## Report to Planning and Environment Committee

**To:** Chair and Members  
Planning and Environment Committee  
**From:** Scott Mathers, MPA, P.Eng.  
Deputy City Manager, Planning and Economic Development  
**Subject:** RAND Developments  
415 Oxford Street West  
**File Number:** Z-9789, Ward 6  
Public Participation Meeting  
**Date:** December 3, 2024

The applicant has requested an amendment to the Official Plan, The London Plan, to amend the existing Specific Policy in the Neighbourhood Place Type to permit two (2), 22-storey mixed-use apartment buildings containing a total of 704 residential units.

Figure 3 - Conceptual Site Plan

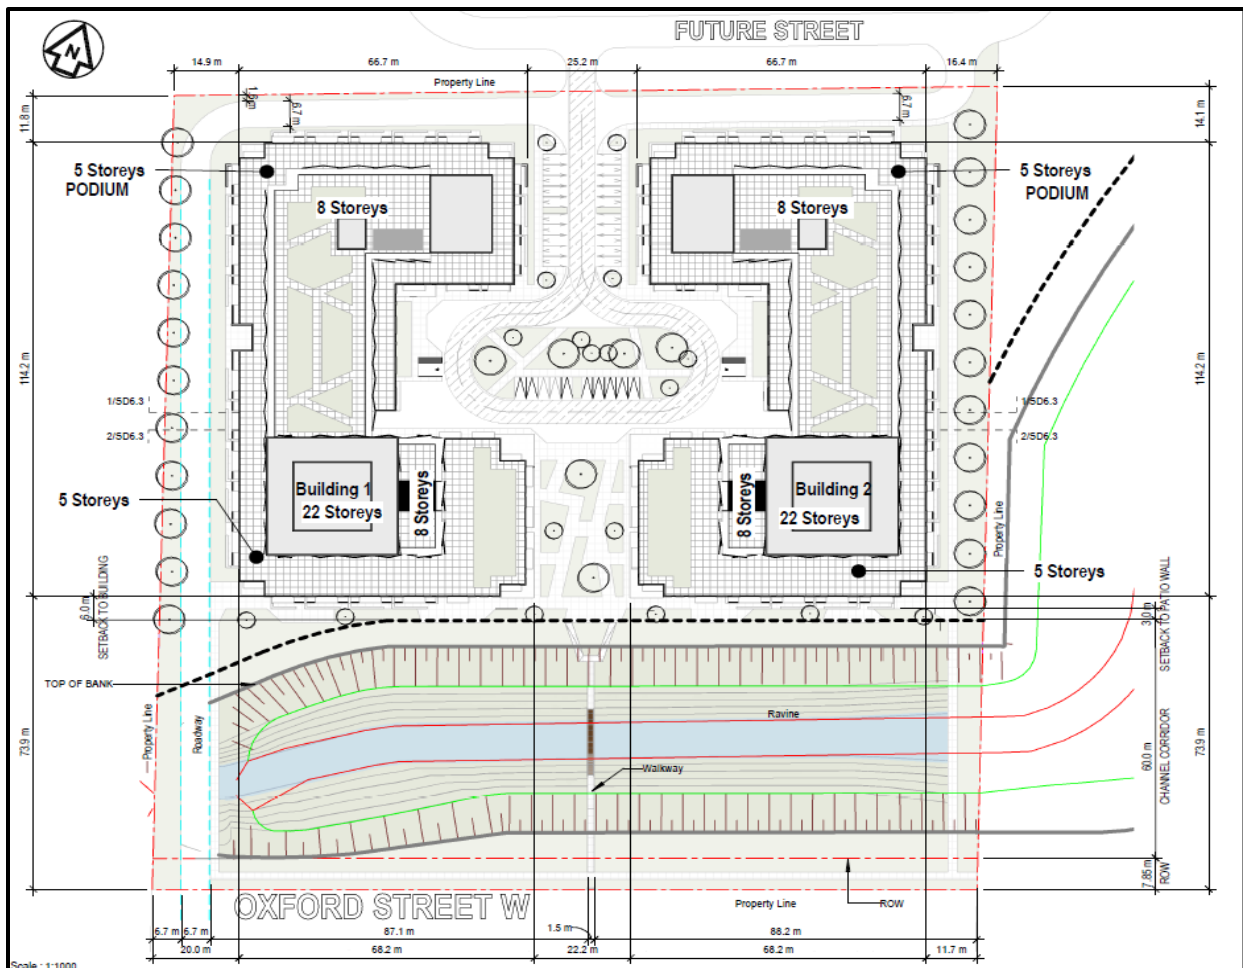
- Parks does not support the proposed private pedestrian pathways and the proposed private bridge connections over the future Mud Creek complete corridor as shown on the plan.

- City of London Transportation Staff are not supportive of vehicular access to Oxford Street West. A pedestrian and cycling connection to Oxford Street West will only be supported by Transportation Staff.
  - An access encroachment agreement would be required for any connection to Oxford Street West once the City of London assumes the Mud Creek channel conveyance.
- The proposed mixed-use development shall not encroach into the Open Space (OS4) zone. Zoning boundaries act as property lines. Refer to the Zoning By-Law Section 3.9(2).
  - Identify the OS4 zone on the provided plans. A reduction in the OS4 zone shall be required to accommodate the proposed development.
- The proposed bridge between Oxford Street West & the proposed built form is not supported by City Staff.

- Transportation cannot accept the current access arrangement. In line with the site plan comments, there must be no vehicular access from Oxford St W. This access point needs to be removed, and all vehicular access should be directed to future subdivision streets.
